service bulletin

91-24

A. ALPHA ONE/MCI 1990 AND PRIOR, LOWER DRIVE SHAFT

71185

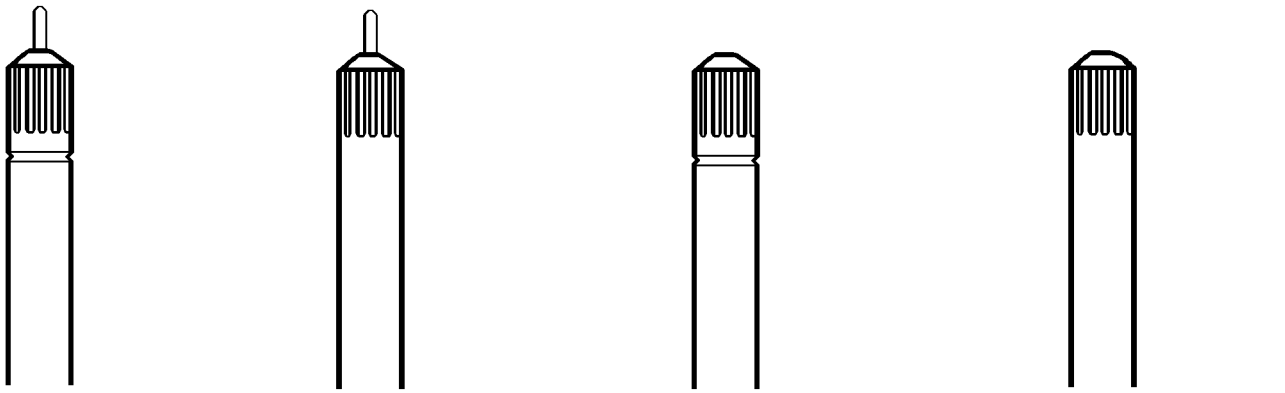
The service drive shaft for the lower unit will no longer have an O-ring groove at the top of the shaft under the splines on all Alpha One 1990 and prior also MCI back through 1976. The drawings below show the old and new configurations for the drive shafts.

OLD STYLE (A)	NEW STYLE (B)	OLD STYLE (C)	NEW STYLE (D)
MCI with the O-ring groove	MCI without the O-ring groove	Alpha One with the O-ring groove	Alpha One without the O-ring groove

Replacement drive shafts from service stock with the following part numbers 45-41939A1 (with top pin)/45-42634 (without top pin) will no longer have the O-ring groove in them.

When installing the complete lower assembly to the upper housing adequately grease the oil seals and the area between the seals in the drive shaft housing, and the splines on the end of the drive shaft with Quicksilver 2-4-C Marine Lubricant (92-90018A).
